Type Ho.Re.Ca. Machine	Model KORO PRIME	N° T.I. 07 - 2019
Serial Number 92311316	Subject NOZZLES SUPPORT MODIFICATION	ISSUED FOR (X) Action Information <input checked="" type="checkbox"/>

Modified *nozzles support*

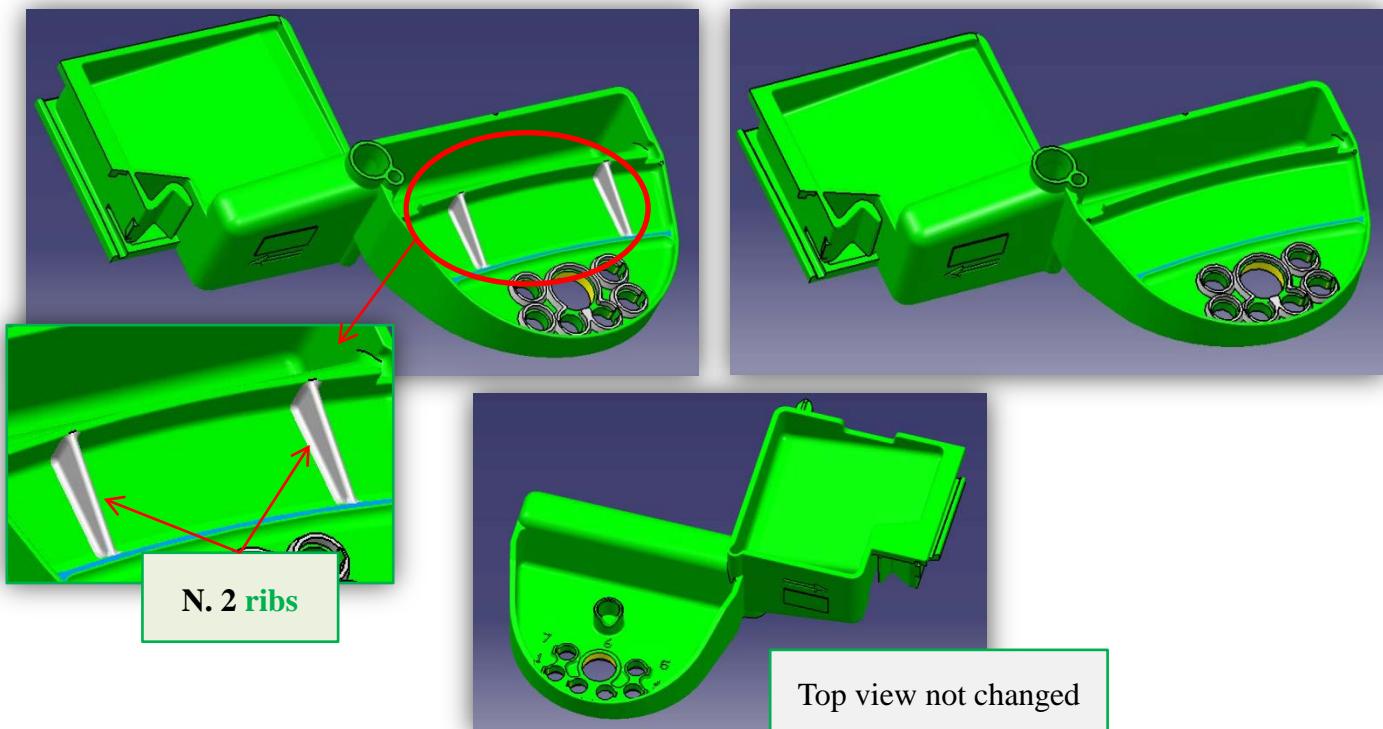
To facilitate the removal and repositioning of the ES coffee grounds tray

The *nozzles support* has been modified by introducing **two ribs** as shown below.

➤ The *nozzles support* spare code is not changed: **251798**

➤ *Machines concerned by modification from S/N:* **92311316**

For machines previous to above **S/N** it's possible to use the **modified** *nozzles support*
